UNITED STATES PATENT AND TRADEMARK OFFICE

APPLICATION NO.	FILING DATE	FIRST NAMED INVENTOR	ATTORNEY DOCKET NO.	CONFIRMATION NO.
10/057,604	01/24/2002	Rosa O. Kelson	13575:10	2927

DETAILED ACTION

FIG. 2

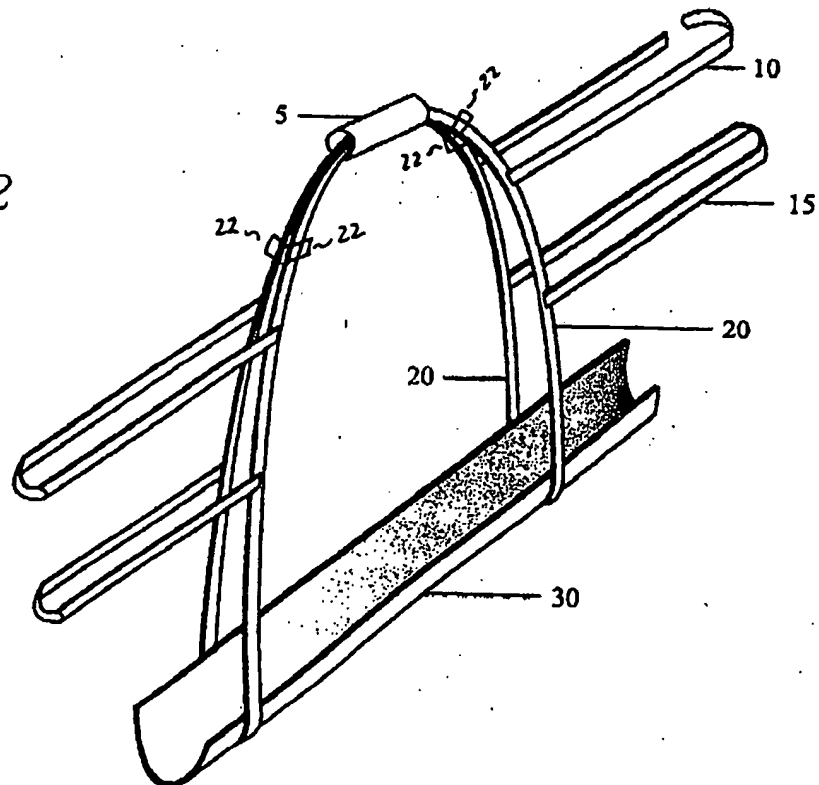
The drawings are objected to under 37 CFR 1.83(a). The examiner states that the drawings fail to show a means for adjusting the length of the carrying straps. The applicant respectfully submits that a proposed drawing correction is attached, wherein a length adjustment device 22 is clearly shown in Figure 2. The applicant respectfully submits that no new matter is added with this drawing correction, as a length adjustment device is identified on page 9, lines 12-13, and the first paragraph on page 10, as currently amended.

A redlined version of page 1 of the drawings is enclosed with corrections. A length adjustment device 22 is added to FIG. 2 at the top of each carrying strap 20.

Approved *see*
7/8/05
